Non Statutory Site Audit Report

Lot 1 DP 620265  
Sark Grove and Pembroke Road  
Minto NSW

Prepared for  
Endeavour Energy  
(formerly Integral Energy)

Project 36339.01  
Audit DPNS/7  
March 2012

**Chart 1 – PSH thickness in sampling events from 2006 - 2011**

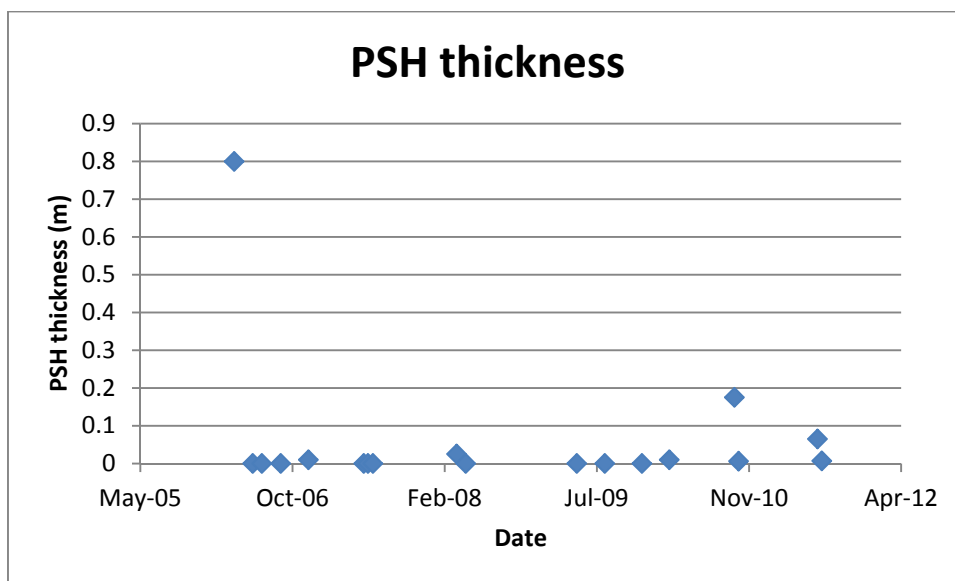
The results are shown in Chart 1 developed by the auditor.

The results are primarily based on the results of measurements taken of PSH thickness in the bailer. In the majority of the fieldwork the PSH was not detected using the interface probe but rather when the visual check was undertaken using the bailer and tape measure. For this reason the consultants have commented that the PSH is *'very thin/absent (actual) PSH layer'* as the visual PSH is likely to be an
